# UNITED STATES PATENT AND TRADEMARK OFFICE

APPLICATION NO.	FILING DATE	FIRST NAMED INVENTOR	ATTORNEY DOCKET NO.	CONFIRMATION NO.
10/758,001	01/16/2004	Eugenio Cruz Garcia	5724.012.21-US	5034
30827	7590	05/05/2005		
MCKENNA LONG & ALDRIDGE LLP 1900 K STREET, NW WASHINGTON, DC 20006			EXAMINER GREEN, CHRISTY MARIE	
			ART UNIT	PAPER NUMBER
			3635

**Office Action Summary**

This is a first office action for serial number 10/758001, entitled New Direct laminated Door, filed on January 16, 2004.

Fig. 1.

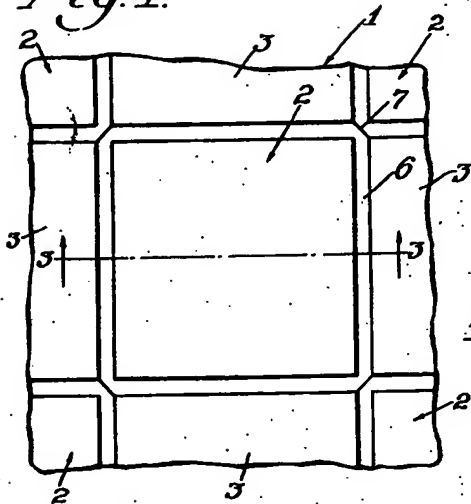
Johnston teaches that it is known in the art to provide a composition of sheets or tile that are mechanically pressed (page 2, column 2, lines 69-70) and cut into a product (page 2, column 2, lines 12-13), the product includes a surface (at 2, figure 1) with both a perimeter area (attached figure 2) having an edge contour (attached figure 3) and an interior region (at 6 – figure 2), where the perimeter area is relieved such that a portion of the edge contour is below the interior region (attached figure 2), a surface texture that varies in accordance with the visual pattern (page 2, column 1, lines 28-34), where the surface (at 2 – figure 1) is formed having a visual pattern (at 15, figure 8 or figure 2) that imitates another product (interpreted to be rough hewn stone or pitted stone – page 2, column 1, lines 29-33), and the edge contour is machined (interpreted to be cut at 7, figure 2, page 2, column 1, lines 13-15); the edge contour has a substantially linear cross-sectional shape (shown in figures 2 and 3) extending from the interior region (at 6 – figure 2) to the edge of the product (attached figure 2; the machining of the edge contour comprising mechanical scraping, milling or cutting (page 2, column 1, lines 13-15); the visual pattern (at 2a and 3a) on the surface extends (shown in figures 1 and 1a)/does not extend (shown in figure 6) into the edge contour; and the surface of the edge contour exposes the interior of the laminated material (“2” – at edge contour in attached figure 3). It would have been obvious to one having ordinary skill in the art at the time the invention was made to provide the elements of the composite sheets as
